Authorized Field Change

AFC 14906

Subject: Clutch Switch Inspection and Replacement.

Model: LoneStar®, ProStar®, and TranStar®
Start Date: 01 March 2013 End Date: 04 February 2014

Figure 1. Clutch Switch Inspection.

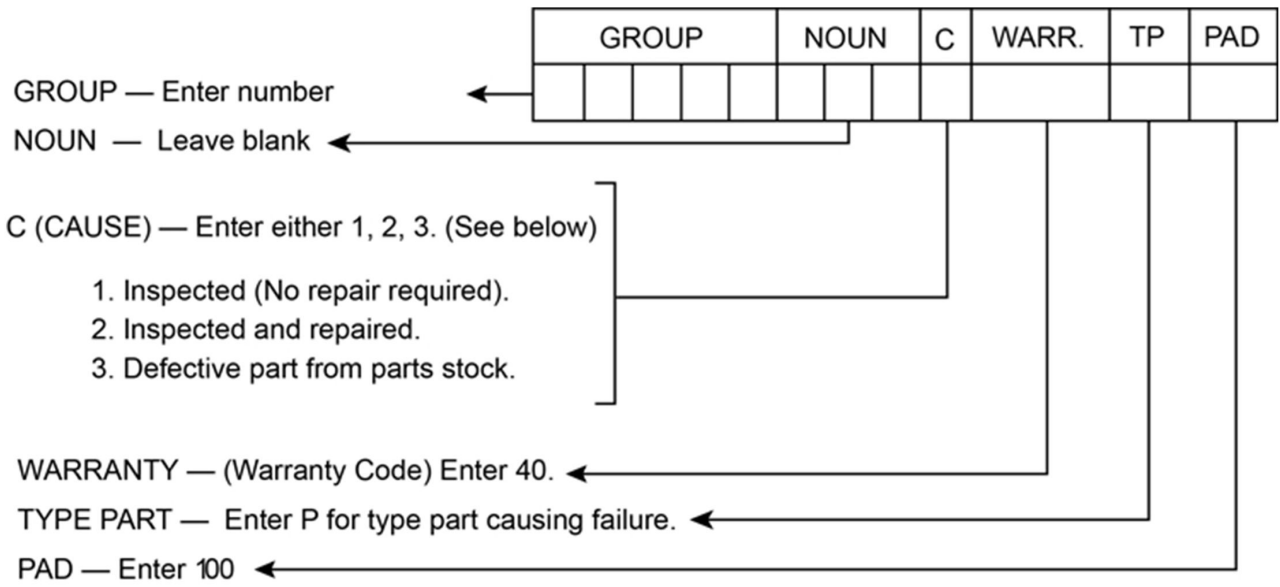
1. Clutch switch
4. Inspect clutch switch (Figure 1, Item 1) color.
 - a. If clutch switch (Figure 1, Item 1) is black, install new clutch switch.

- b. If clutch switch (Figure 1, Item 1) is not black, clutch switch does not need to be replaced.
5. Replace master cylinder, if vehicle was built between 04 November 2013 and 04 February 2014 at Escobedo, or between 20 December 2013 and 04 February 2014 at Springfield. Refer to [Service Manual Section, Hydraulic Clutch Service Manual, S11018](#).
6. Verify clutch switch operation by depressing clutch pedal to crank vehicle. Starter should engage in a range from a little before to just after clutch brake contact, which is indicated by pedal coming to a stop with same amount of effort being applied to clutch release pedal as was used to stroke clutch release pedal.
7. Install two modesty panels onto vehicle with one M6 x 35 mm bolt, one M8 x 45 mm bolt, and 11 screws.
8. Remove wheel chocks.
